DC25/29  
16 June 2025

**OBJECTION TO DC/25/139604 – BLACKHEATH STATION CAR PARK**

Proposed north elevation of Block B

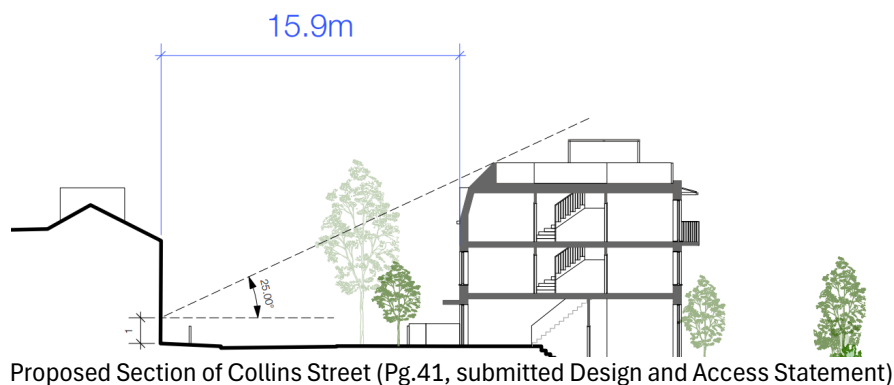
3.10 The proposed Block B would introduce a significant unbroken mass of horizontal development that has no relief. Being visually impenetrable and a storey higher than the adjacent terrace on Collins Street it would present as a barrier to views into and out of the Conservation Area in addition to harming the setting and special historic character of listed buildings at the lower end of Tranquil Vale.

Proposed Block C

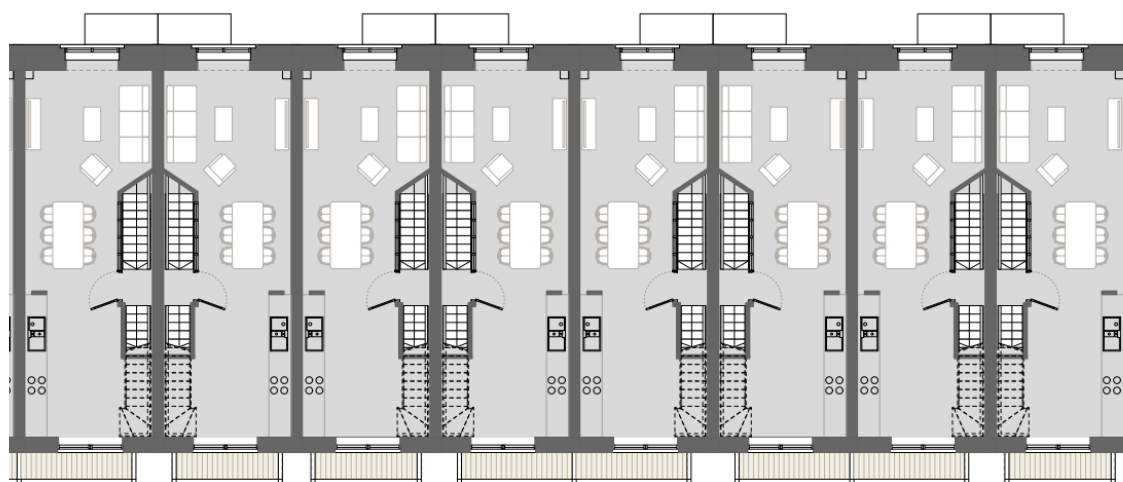
3.12 Block C is of significant height, rising to over 16m, and does not benefit from any significant relief, either in its height or elevational mass. The sheer scale of the building is challenging to comprehend given the extent of the juxtaposition it would have with its surroundings.

3.13 Whilst the submission documents present the proposals as relatively appropriate heights it is inappropriate to compare the height of Block B to Block C and so forth. A more appropriate barometer for assessment is the prevailing pattern of development that gradually extends higher to the north of the site (i.e. the adjacent Collins Street is two-storey, Southvale Road further north three-storey and parts of Camden Row and Tranquil Vale extending to four-storey, inclusive of rooms within roofscapes), aided by the rising topography. The proposal does not respect this established pattern of

Proposed Block B Second Floor Floorplans

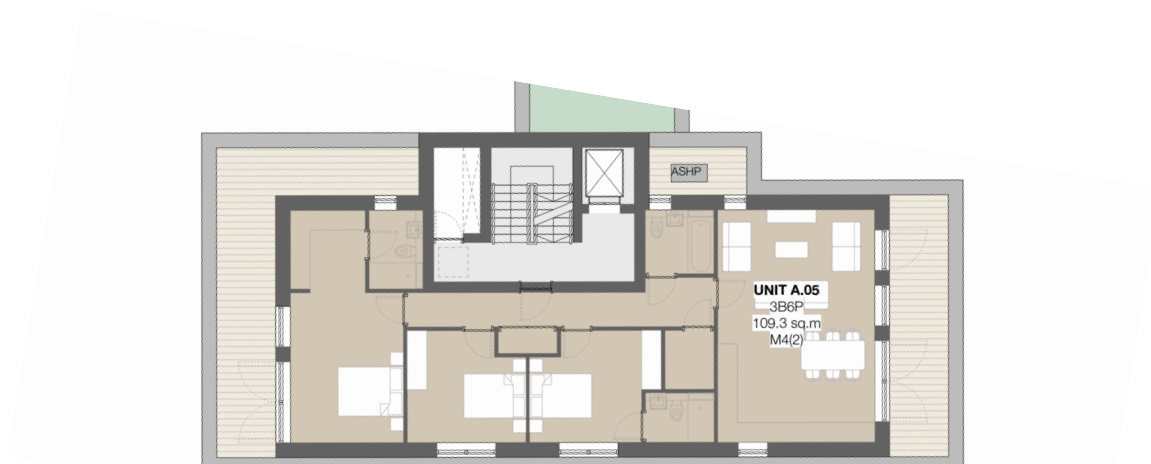
4.2 The proposed units facing Collins Street would have primary living accommodation, in the form of a lounge, facing directly towards the existing terraced dwellings. Given that the dwellings on Collins Street have bedrooms at first floor level this means that there will be direct, and unacceptable, overlooking down into the bedrooms.
